Expert Statement

NPP ZAPORIZHZHYA LIFETIME-EXTENSION ENVIRONMENTAL IMPACT ASSESSMENT

REPORT
REP-0775

VIENNA 2021

Figure 5:
Status of implementation of new and revised RL in Ukraine

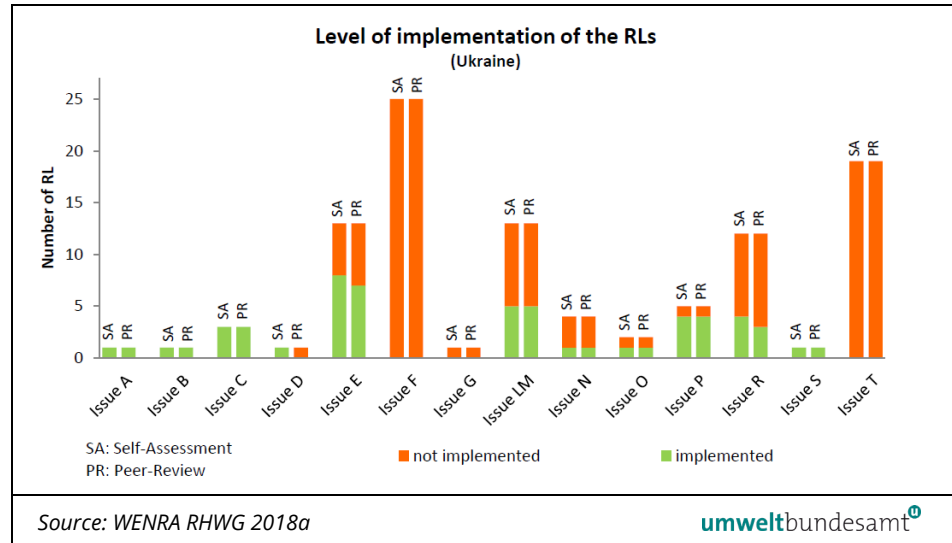
(March 2016). It illustrates that Ukraine has not implemented the new RL F and T in the regulations at that time.

Figure 6:
Reported status of implementation of 2014 RL in 2020

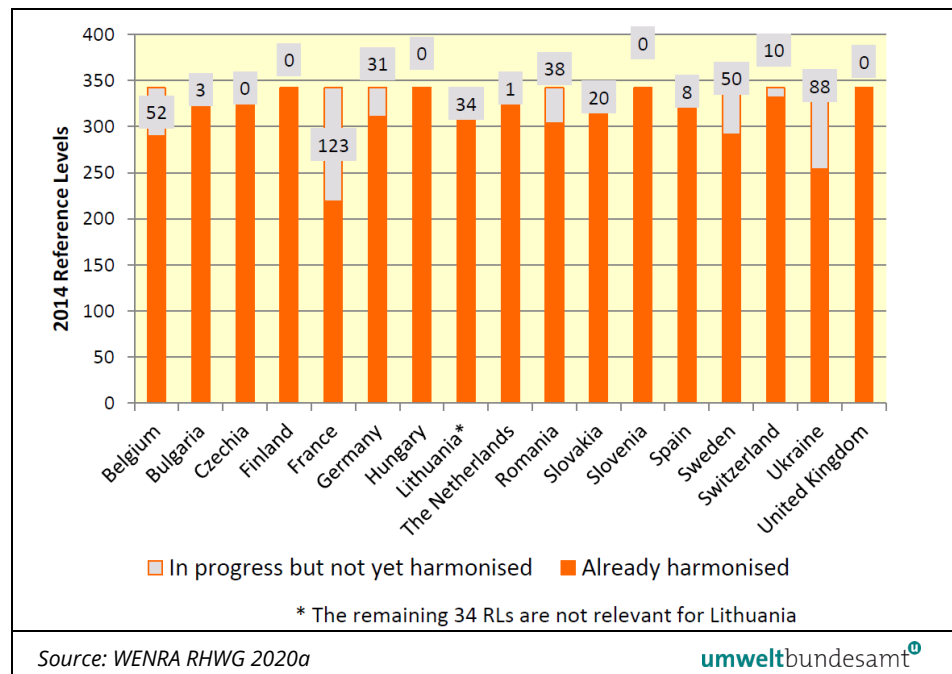
Ukraine proposed the fully implementing the remaining 74 RLs into the national regulation until March 2018. However, it has to be noted that Ukraine has not implemented 88 RL of the 342 at the 1 January of 2019, see Figure 6. (WENRA RHWG 2020a)

SNRIU is a member of the Western European Nuclear Regulators Association (WENRA). In 2014, WENRA published a revised version of the Safety Reference Levels (RLs) for existing reactors developed by the Reactor Harmonisation Working Group (RHWG). The objective of the revision was to take into account lessons learned of the TEPCO Fukushima Daiichi accident. A major update of the RLs was the revision of Issue F "Design Extension of Existing Reactors" introducing the concept of Design Extension Conditions (DEC). However, it has to be noted that Ukraine has not implemented 88 RL out of the 342 until the 1 January of 2019.

Figure 7:
Average deposition of
Cs-137 after a hypothet-
ical BDBA in ZNPP 3.

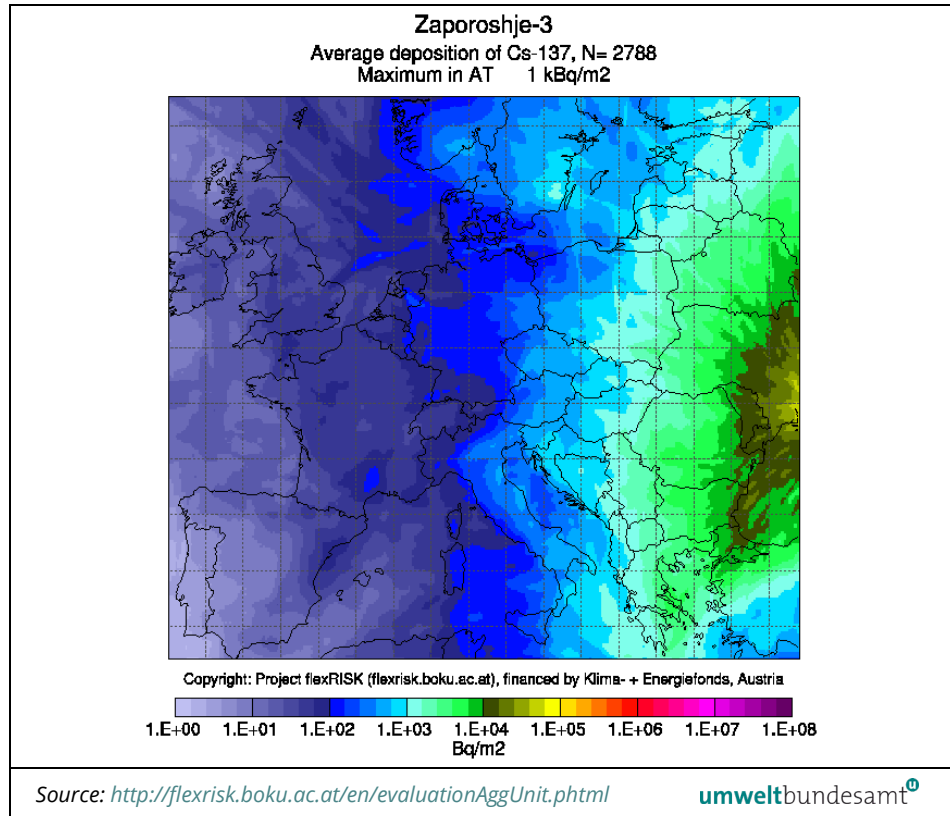
Figure 7 illustrates the average deposition of Cs-137 after a severe accident at ZNPP-3 with the Cs-137 release of 51.05 PBq. Such an accident could result in a considerable contamination of the Austrian territory; the average deposition of Cs-137 in the simulation is up to 1,000 Bq/m².

Figure 8: Weather-re-
lated probability for a
contamination exceed-
ing 5 kBq Cs-137/m² as a
consequence of a severe
accident at ZNPP 3.

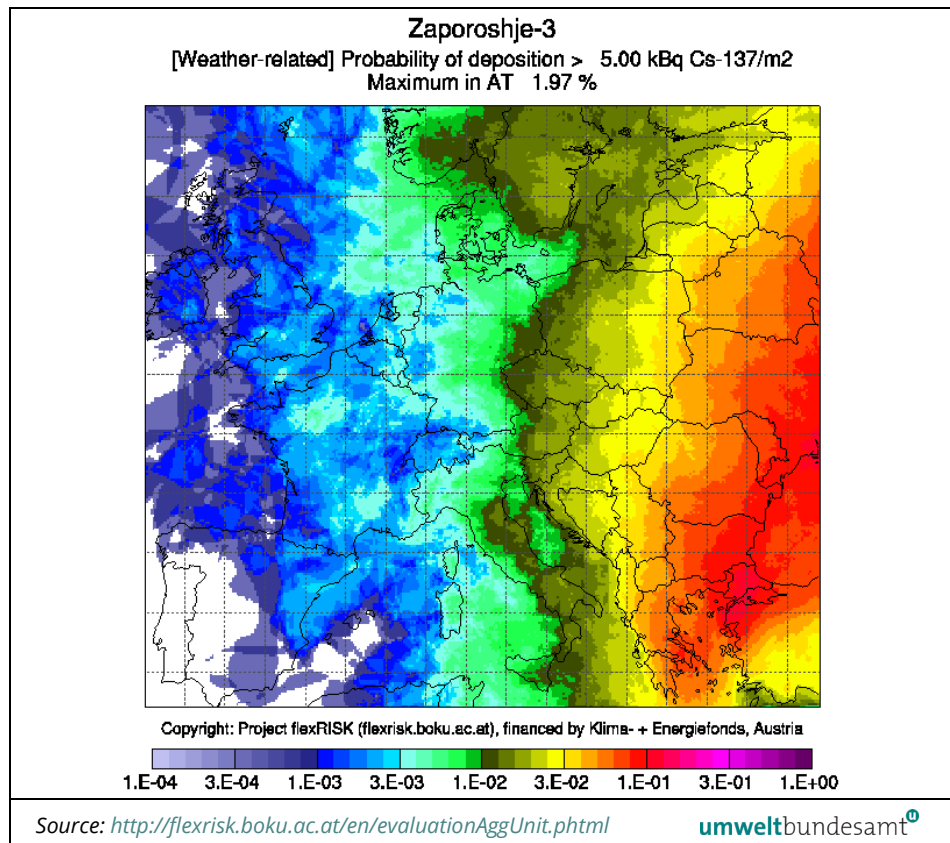
flexRISK determined the weather-related probability for a contamination of Austrian territory with more than 5 kBq Cs-137/m² with 1.97% (see Figure 5). The weather-related probability for a contamination above 37 kBq Cs-137/m² is 0.43%, for more than 185 kBq Cs-137/m² 0.07%, respectively.

A contamination of 5 kBq Cs-137/m² as shown in Figure 8 is much higher than the level for the Cs-137 contamination in the above table, therefore agricultural countermeasures could be necessary on Austrian territory in case of a severe accident at the Zaporizhzhya site.
